**SERVICE LETTER**

**FOR INSTALLATION OF OVERFLOW SHROUD**

**ON THE SIMPLEX MODEL 326**

Document No.: SL2009-008  
Date: October 15, 2009  
Used On: Simplex Model 326

Figure 1-1

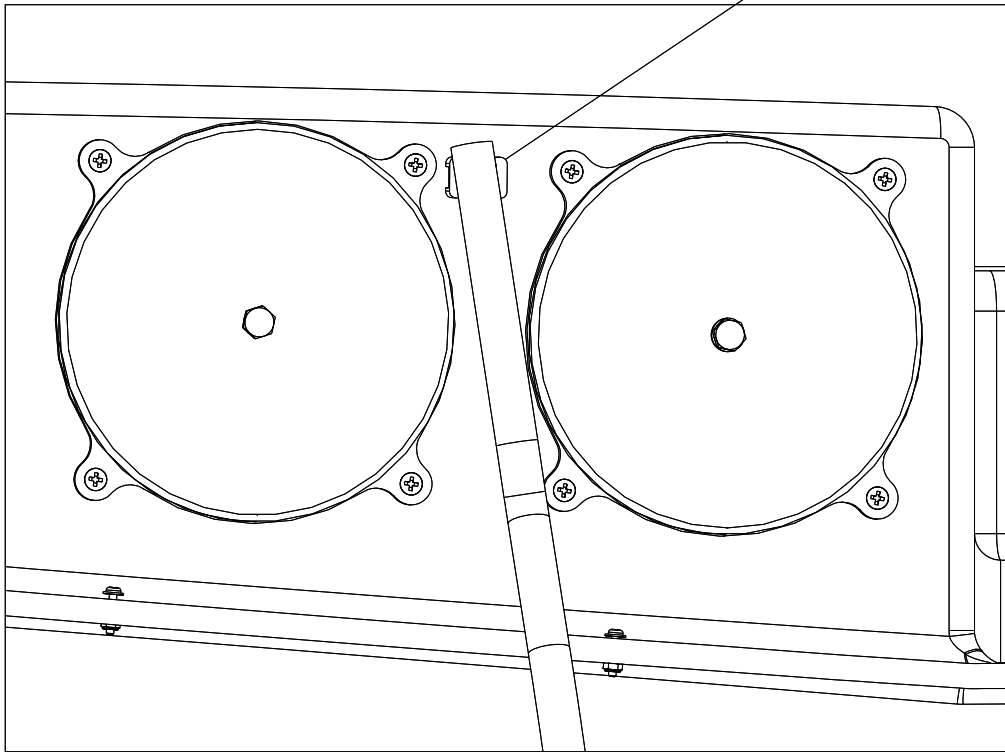
<b>Step</b>	<b>Description</b>
1	Remove upper sight tube support bracket from tank assembly. See Figure 1-1.
2	Seal open rivet hole with pop rivet and silicone.
3	Place aluminum bracket assembly P/N 326-302061-501 on tank as shown in Figure 1-2.
4	Match drill two (2) .191 diameter holes from bracket into tank shell.
5	Secure bracket to tank using hardware listed below. Seal using standard RTV silicone or Pro-seal. <ul style="list-style-type: none"><li>• 2 ea. 000-113101-000 (MS35207-267) screw</li><li>• 4 ea. 000-112040-000 (AN960C-10) washer</li><li>• 2 ea. 000-111180-000 (MS21044-C3) locknut</li></ul>
6	Temporarily install new shroud to tank using existing hardware (no sealer).
7	Using bracket assembly P/N 326-302061-501 transfer bolt pattern to shroud. See Figure 1-3.
8	Remove overflow shroud.
9	Drill two (2) .191 diameter holes in new shroud using pattern from step 7.
10	Route sight gauge to sight gauge supports on bracket assembly P/N 326-302061-501 and secure to bracket using zip ties.

REMOVE SIGHT GAUGE BRACKET

Figure 1-2

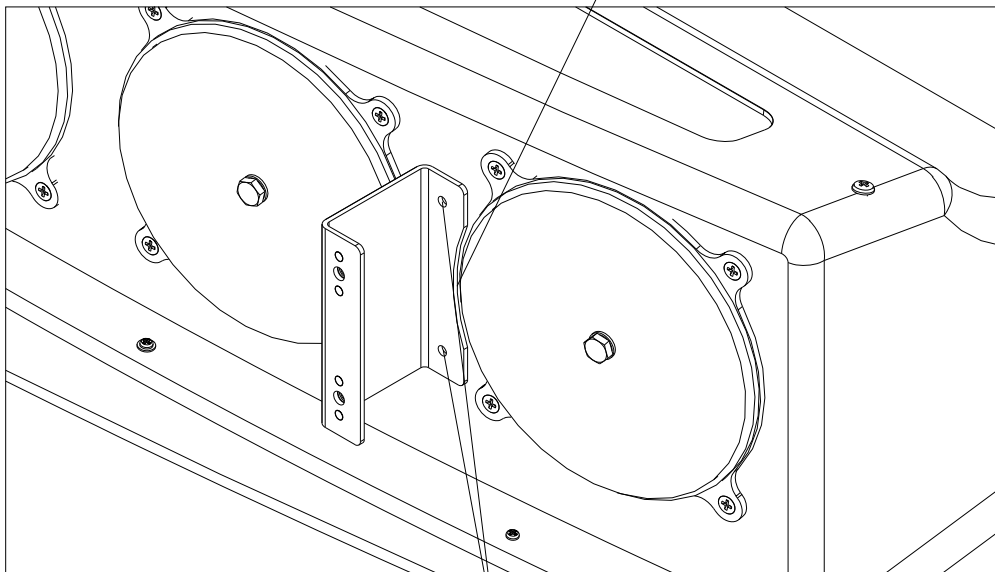
CENTER BRACKET ON VENT RADIUS

MATCH DRILL THRU TANK

Figure 1-3

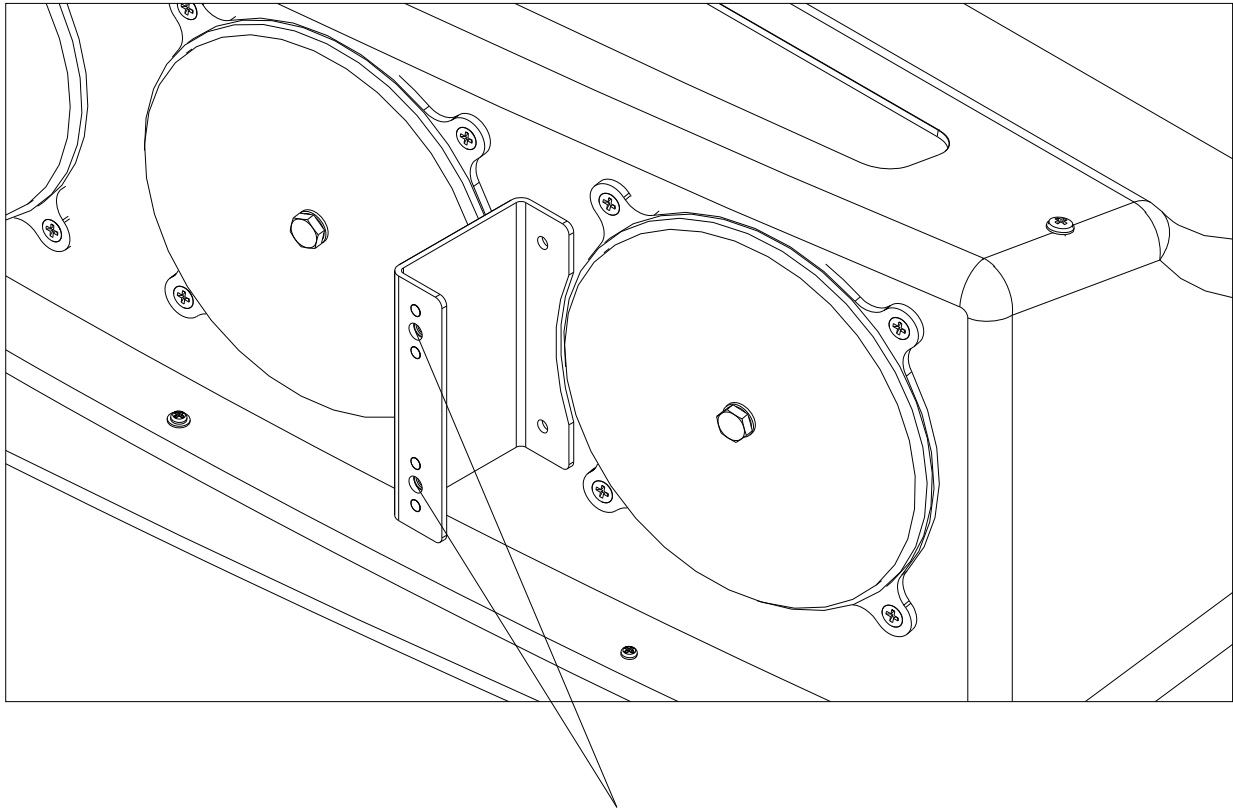
11	Install new shroud to tank shell using existing hardware. Seal shroud to tank mating surfaces using Pro-seal.
12	Secure new shroud to bracket assembly P/N 326-302061-501 using the following hardware: <ul style="list-style-type: none"><li>• 2 ea. 000-113093-000 (MS51958-64) screw</li><li>• 2 ea. 000-112404-000 (MSAN960C-10) washer</li></ul>

TRANSFER BOLT PATTERN INTO OVERFLOW SHROUD
